L-2015-128
10 CFR 52.3

April 27, 2015

Re: Florida Power & Light Company
Proposed Turkey Point Units 6 and 7
Docket Nos. 52-040 and 52-041
Correction of Evacuation Time Estimate - Revision 4 Figure H-23 Error

Figure H-23. Region R23

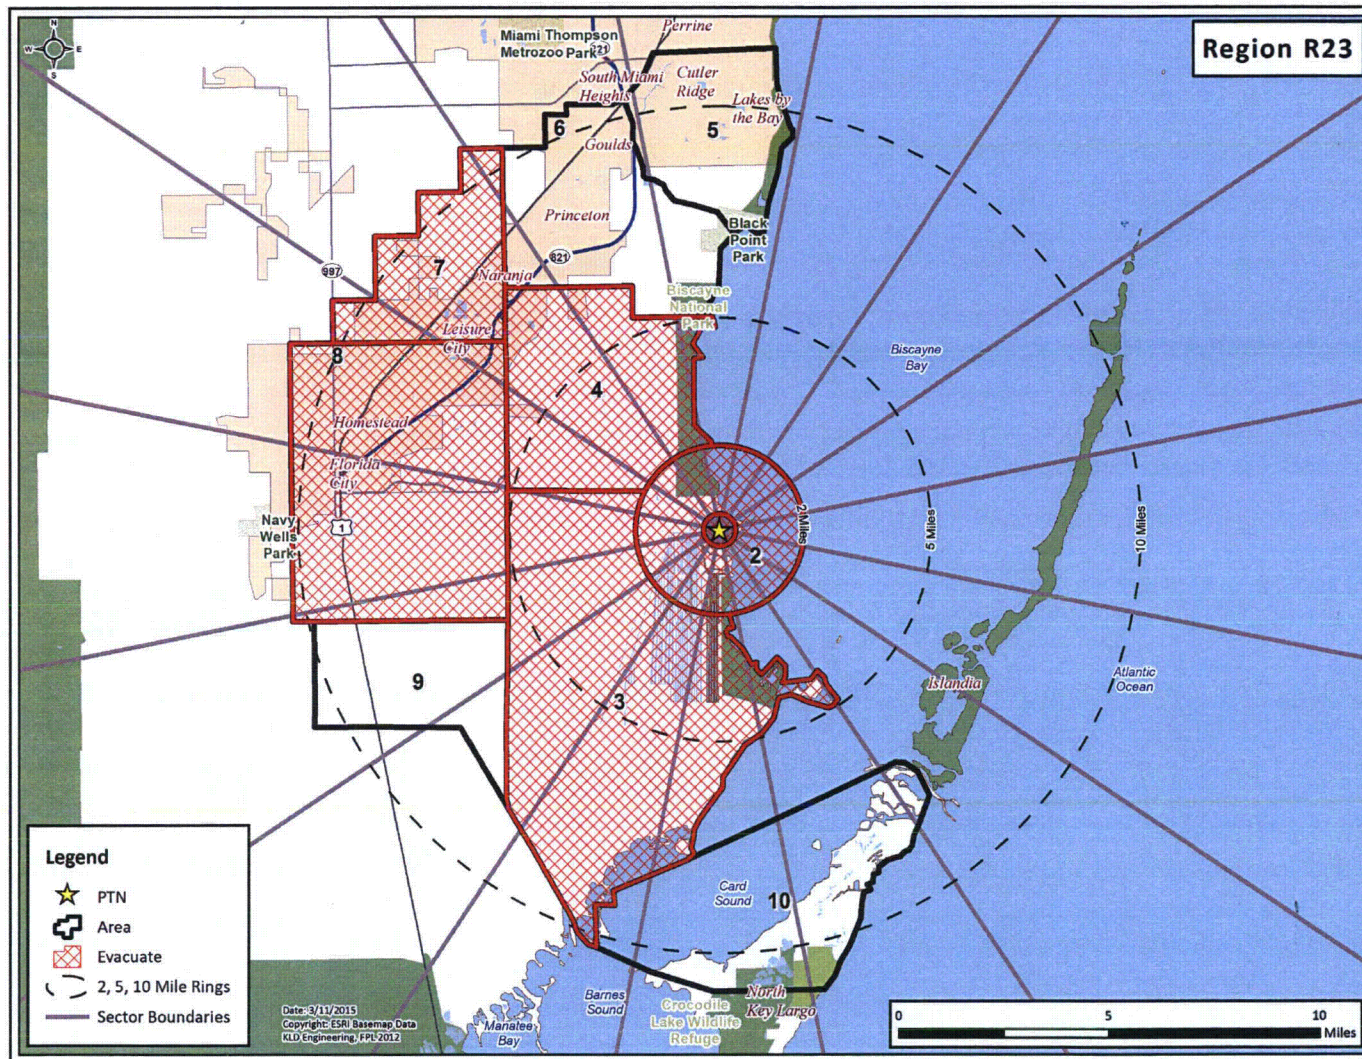
In Revision 4 of the ETE, FPL added 3 new regions. The description of these three regions was provided in ETE Table 6-1, Description of Evacuation Regions. Region 23 is identified as consisting of areas 1, 2, 3, 4, 7, and 8. However, ETE Figure H-23, Region R23, which represents Region 23, shows areas 1, 2, 3, 4, 8, and 9 as evacuating with this region.

FPL and its ETE contractor investigated and confirmed that the error was solely in the documentation, as presented in Figure H-23. FPL's contractor initiated a corrective action report, checked the simulation model input streams, and confirmed that the simulation model input streams were correct for Region R23. As such, the evacuation time estimates for Region R23 are accurate. An incorrect combination of areas in the GIS map was used to generate Figure H-23 for ETE Revision 4.

The Attachment of this letter provides a copy of the replacement Figure H-23. The corrected figure will be incorporated into the Turkey Point Units 6 & 7 COL Application Revision 7.
